Subject: Byron Generating Station Units 1 and 2
Technical Specifications
NRC Docket Nos. 50-454 and 50-455

This is to provide additional comments and suggestions regarding the proof and review version of the Byron 1 Technical Specifications that was distributed in reference (a). NRC review of specific changes proposed here is necessary before the Technical Specifications can be finalized.

Attachments A through J to this letter contain marked-up pages of various sections of the Technical Specifications. A summary explanation of the changes is provided for each attachment. Justifications are provided where appropriate.

FIGURE 3.2-3. N-LOOP OPERATION FLOW VS. F_{AH}^N LIMIT - CYRON/BRADWOOD

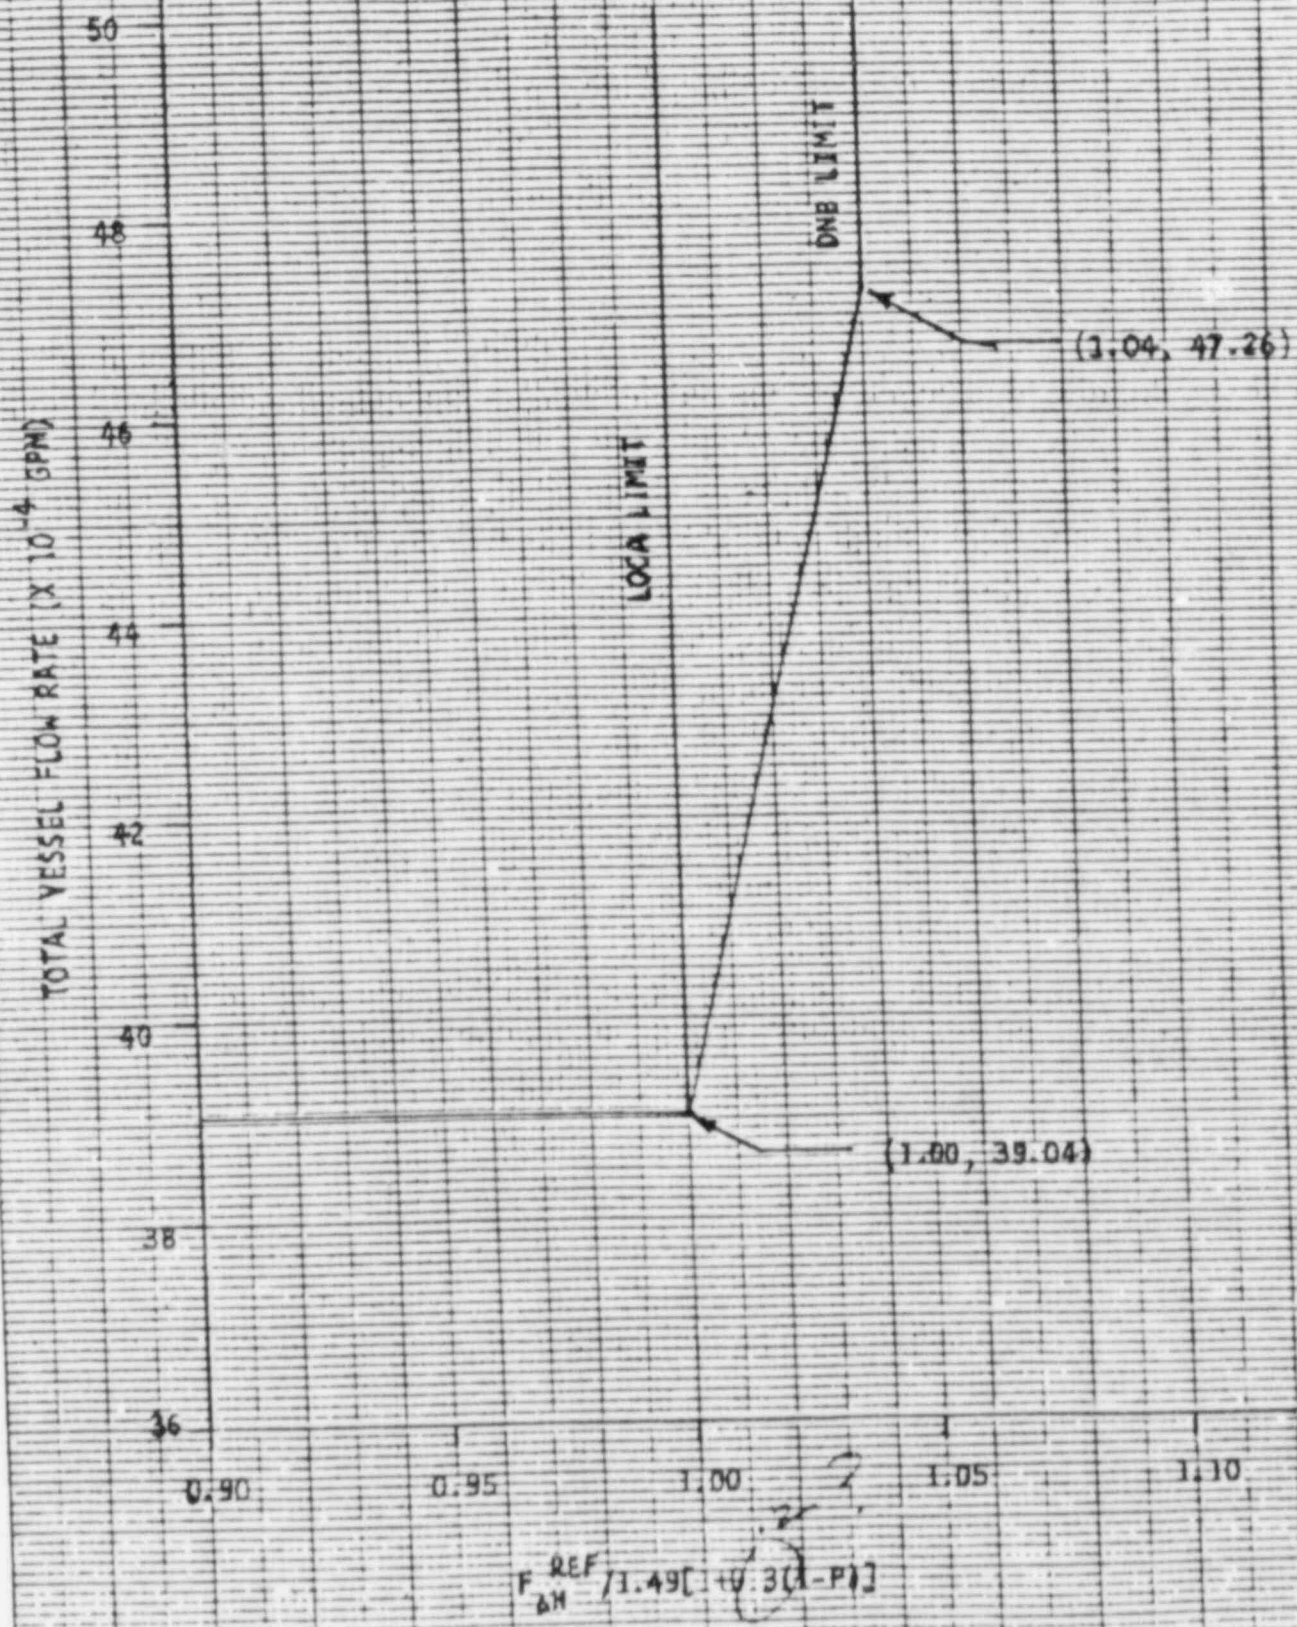
- 1) Figure 3.2-3 (pg. 3/4 2-9) RCS Total Flow Rate Versus R.
